VILLAGE OF GERMANTOWN
N112 W17001 MEQUON ROAD
GERMANTOWN, WI 53022

MEETING:	PLAN COMMISSION
DATE AND TIME:	MONDAY, OCTOBER 9, 2017 6:30 p.m.
LOCATION:	Germantown Village Hall Board Room

10/9/17 Plan Commission Meeting

Keller Inc., agent for Germantown Development LLC, property owner and Germantown Storage are seeking approval of a rezoning application and site development and building plans for a 77,415 sqft addition to the existing indoor mini-storage facility on a 3.5-acre parcel located at N112 W18518 Mequon Road.

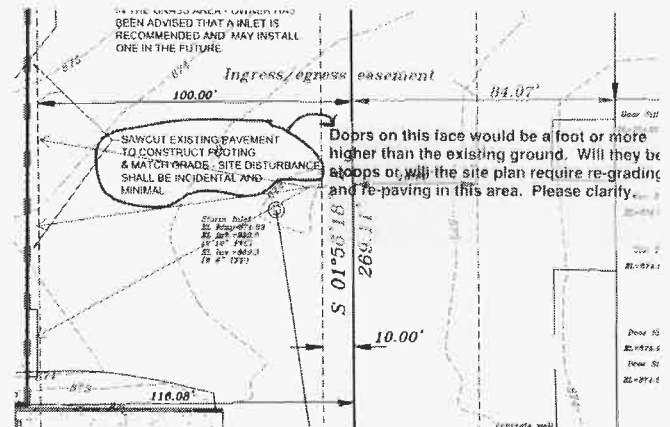
1. *Per state plumbing code storm sewer 12" and larger shall be provided with a manhole at any change in direction of 45 degrees or greater and a manhole or catch basin is recommended at the end of the line. Revise plan to include manholes or catch basins at the changes in direction per code.*

2. *Storm sewer labeling isn't clear. Some pipe segments are labeled and some are not. It's not clear what the length shown represent and invert elevations do not appear to match slopes called out. Please revise callouts to label length, pipe size, and slope for each pipe segment. Review the sizing for the north line, the architectural plans show the roof all draining to the north, Civil calcs only show flow for half.*

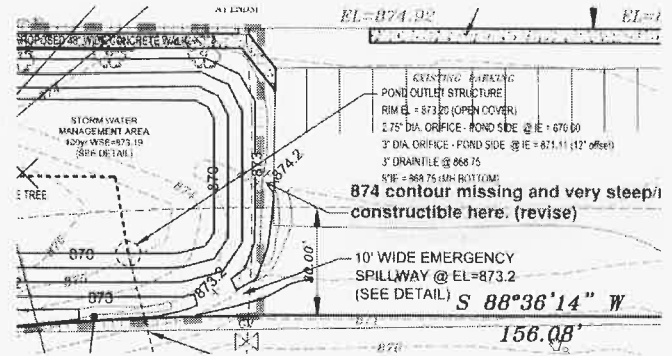
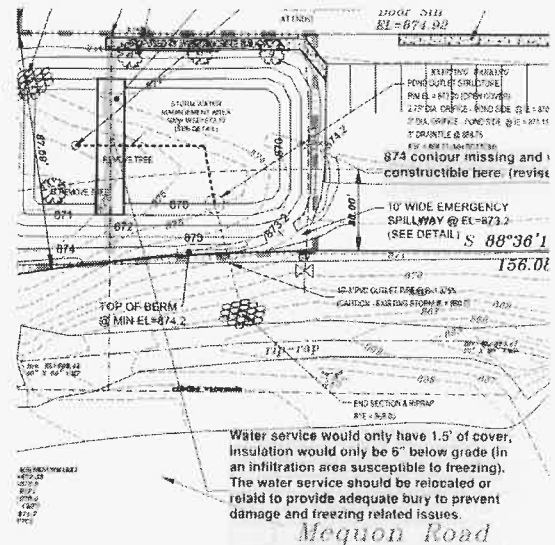
6. Contours, spot elevations, and notes do not match on the south/southeast side of the pond. Revise to show how proposed grades will tie into existing and how overflow will be graded. **874 contour is missing on east side and needs to be extended on south.** Also, if there is access from the building to the proposed walk on the north side, the grading and contours should reflect that (there is a 1' differential from floor to outside contour grade). Perhaps if the grading/slopes were increased to 3:1 in areas where more space was needed it would assist in getting the required contours and elevations to fit.

7. Is this a water valve or a gas valve? Show location of utility this valve is for and confirm that adequate cover is provided if utility crosses through the proposed basin and outlet area. **The Existing water service will have little to no cover (1.5') on it after the basin construction. The Water service should be relocated or re-laid to prevent damage.**

8. Show existing 8" east west storm sewer and verify no conflict with the pond outlet pipe. **Would recommend increasing invert depth at outlet as the pipes will be sitting on each other at the current inverts.**
9. West face of the proposed addition appears to be right at the edge of the 35' public utility easement. Verify footings / foundation / overhangs will not encroach on the easement. An encroachment agreement will likely be required for the proposed private storm sewer within the municipal easement.
10. Consider adding an inlet at the northeast corner of the proposed addition to collect runoff prior to runoff going across the pavement and creating an icing and nuisance condition. Inlet could be connected to the existing inlet in the pavement to maintain existing drainage areas.

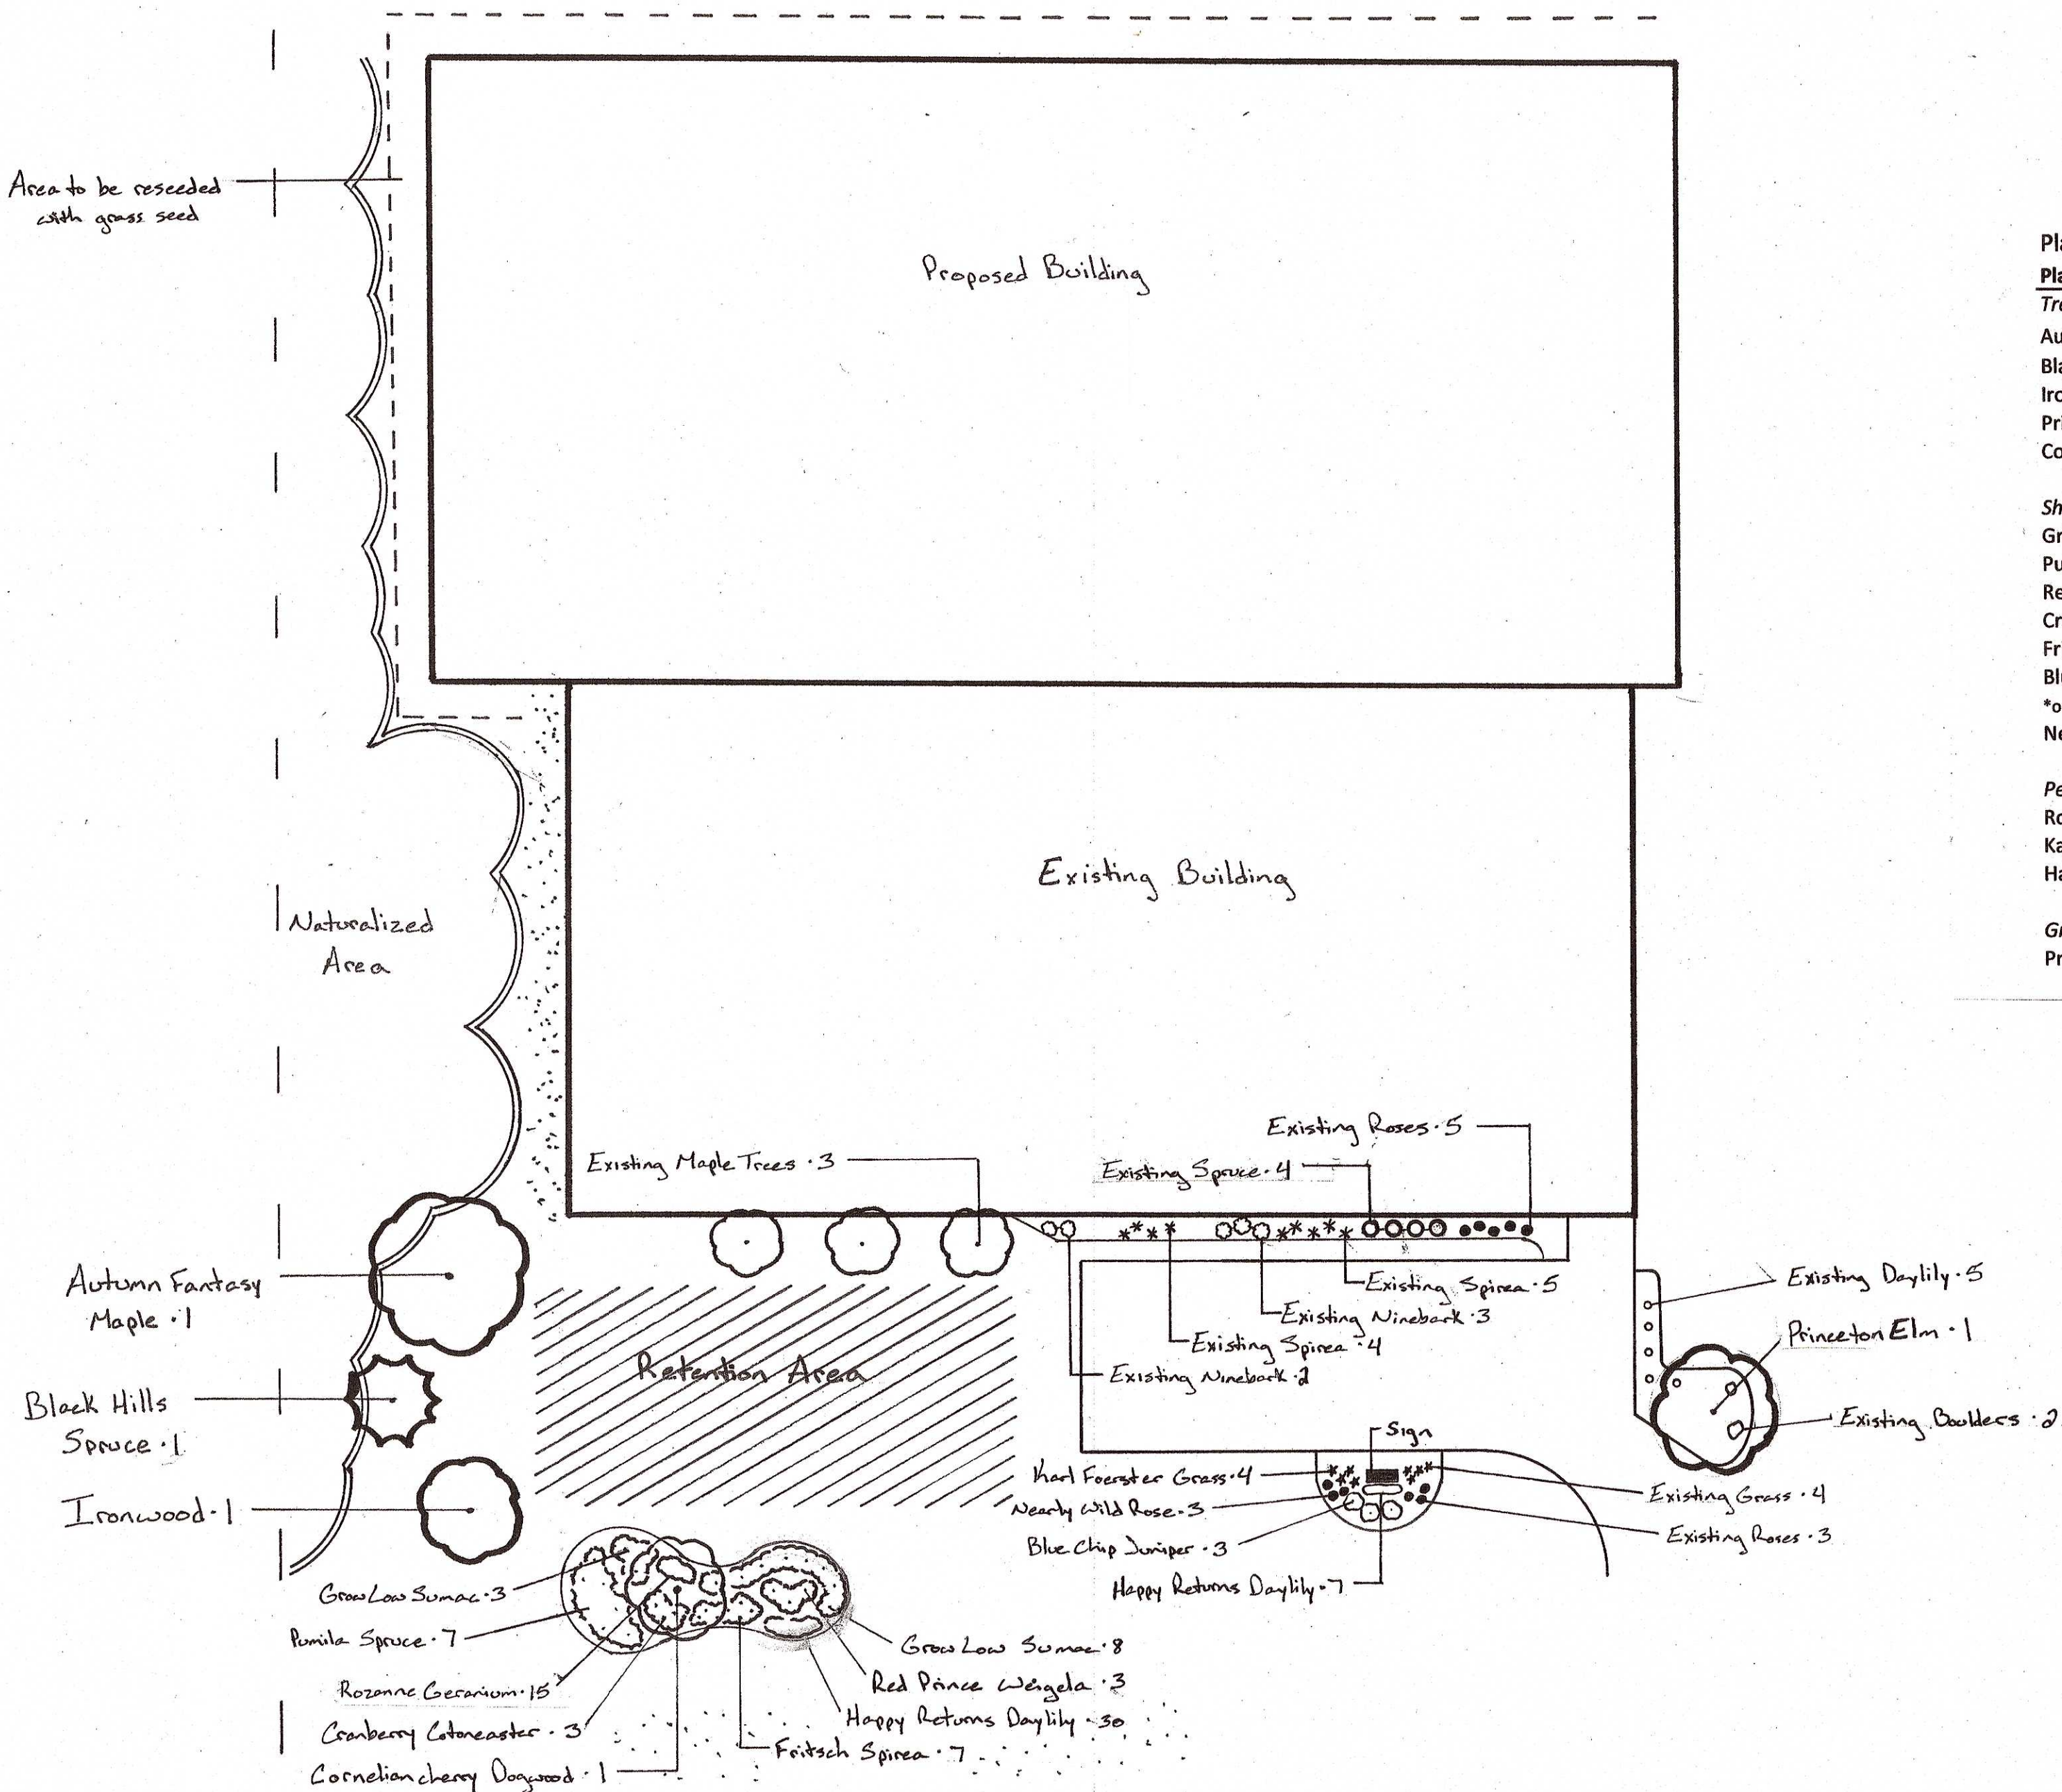
The landscape plan is prepared on a separate sheet with only a few key landmarks from the site shown. As a result, when you compare the landscape plan to the site plan on Sheet C100, it's obvious see that there's no room to install the proposed landscaping in front of the proposed storm water pond yard adjacent to Mequon Road. As shown, the landscaping is proposed to be installed in the Mequon Road right-of-way... which is not allowed. The landscape plan needs to be revised and prepared over the proposed site plan with all the key features shown (including property lines) so that the landscape plan is feasible and all plantings are installed on the subject property. It appears that the proposed "grouping" of plantings shown south of the storm water pond could be relocated & reoriented to the east in front of/adjacent to existing parking lot east of the pond. However, a revised plan needs to be prepared and submitted for approval.
